Access Compliance Report

Public Rights-of-Way

Intersection ID: 47982	Main Street: WHEAT RIDGE RD	Cross Street: SOUTH CREEK RD	Location: SE
ADA ID: 8ED3C802C0B6	Ramp Type: Perpendicular	Initial Pass/Fail: Fail	Overall Compliance: No
Severity Score: 12.5			
Codes/Mitigation Info/Possible Solution		Field Measurements/Component Compliance

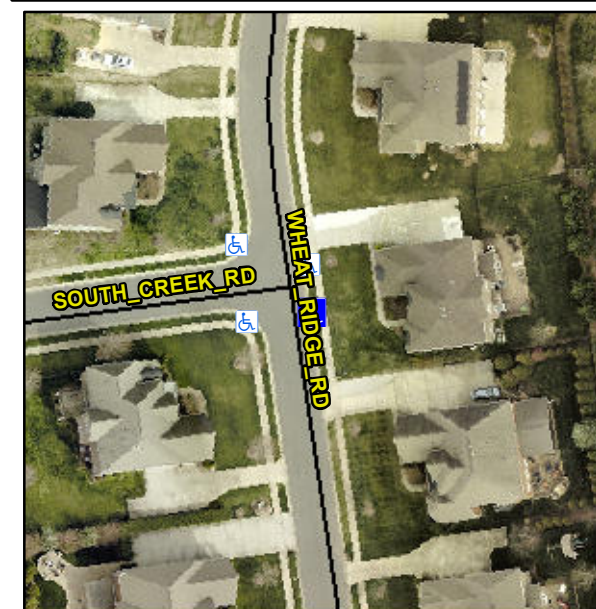
Not Found, R304.2.2

Compliance	Description	Data	Compliance	Description	Data
N/A	Ramp Length (in)	46.0	No	Ramp Slope (%)	9.0
Yes	Ramp Width (in)	48.0	Yes	Ramp XSlope (%)	1.4
N/A	Flare Type LT	N/A	N/A	Flare Type RT	N/A
N/A	Flare Slope LT (%)	N/A	N/A	Flare Slope RT (%)	N/A
N/A	Flare Traversable LT?	N/A	N/A	Flare Traversable RT?	N/A
N/A	Landing Length (in)	N/A	N/A	DWS Provided?	N/A
N/A	Landing Width (in)	N/A	N/A	DWS Contrast?	N/A
N/A	Landing Slope (%)	N/A	N/A	DWS Length (in)	N/A
N/A	Landing X Slope (%)	N/A	N/A	DWS Full Width?	N/A
N/A	Landing Curb? (Y/N)	N/A	N/A	DWS Offset (in)	N/A
N/A	Shared Landing?	N/A			
N/A	Gutter Ponding?	N/A	N/A	Gutter Slope (%)	N/A
N/A	Gutter Lip Ht (in)	N/A	N/A	Gutter X Slope (%)	N/A
N/A	Painted X Walk1?	No	N/A	Painted X Walk2?	N/A
	X Walk 1 Direction	To W		X Walk 2 Direction	N/A
N/A	X Walk 1 Width (in)	N/A	N/A	X Walk 2 Width (in)	N/A
	X Walk 1 Slope (%)	3.3		X Walk 2 Slope (%)	N/A
	X Walk 1 X Slope (%)	1.2		X Walk 2 X Slope (%)	N/A

Remove & Replace Entire Ramp.
